Construction Division
Additions & Alteration Charges Approval Form

GULMOHAR RESIDENCY

Details of Additions & Alterations

Flat No	H-103.	Block no.	H
Flat Area	sft	Type	Deluxe / Luxury
Buyer Name	Mr. Lakshmi Prasad.		
Phone No.	9739900335	Email	lakshmi.prasad@gmail.com.

Other Changes:

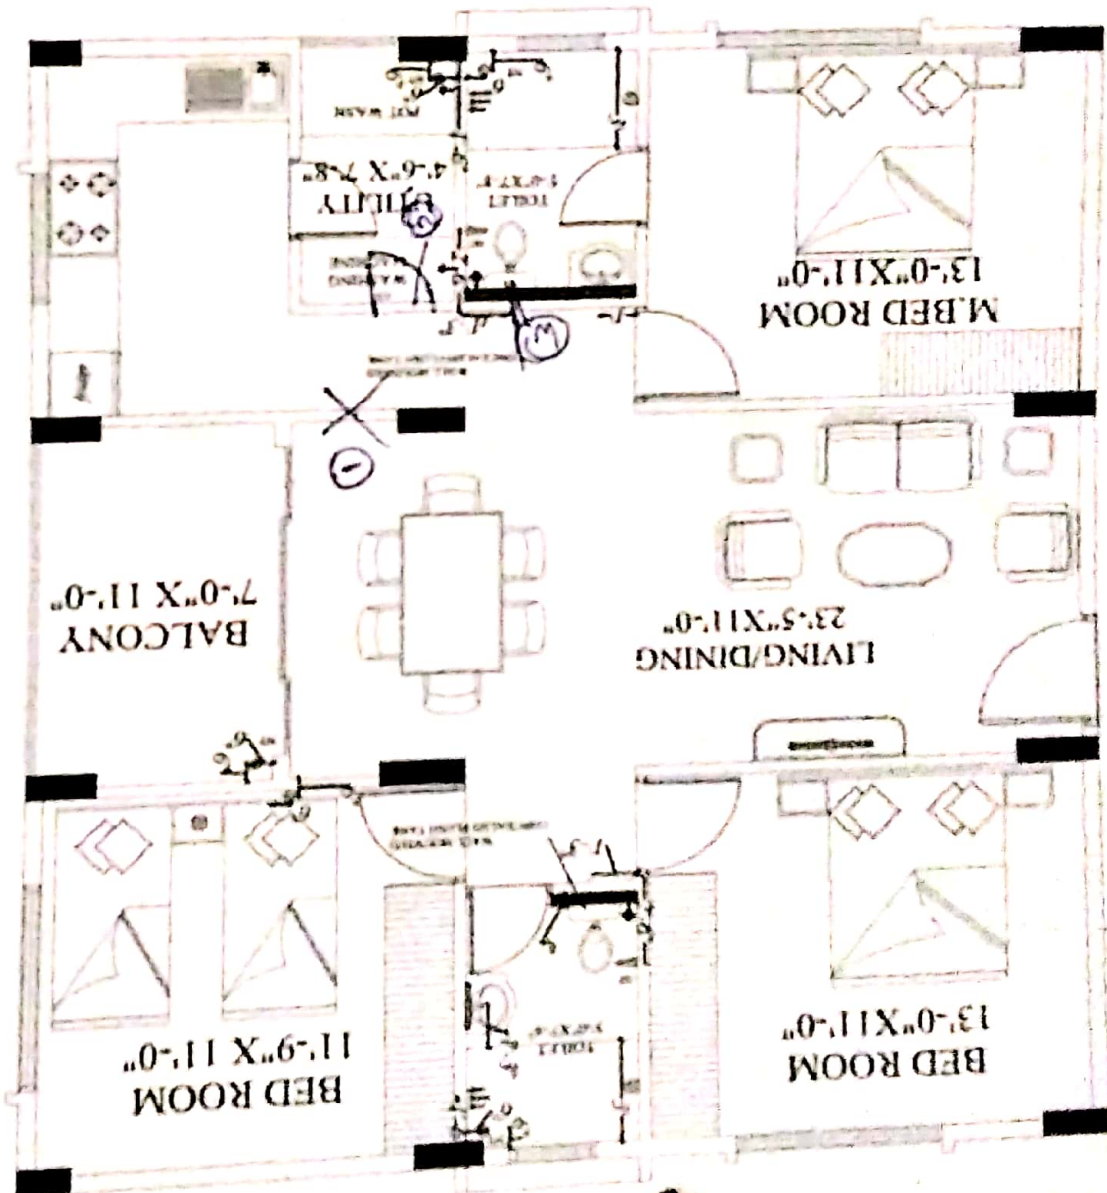
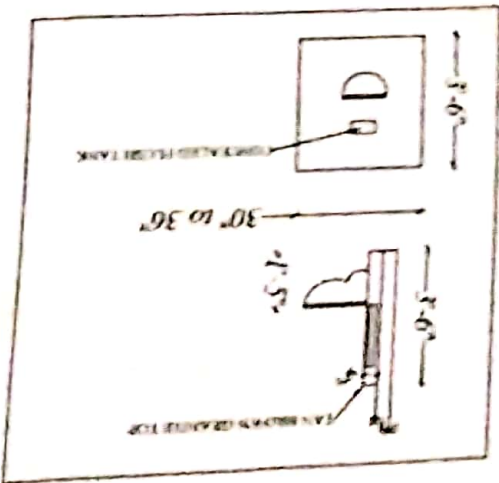
- ① Removing of wall
- ② Utility door position changing.
- ③ Extra wash basin point.
- ④ Change of ~~top~~ washing machine top point.
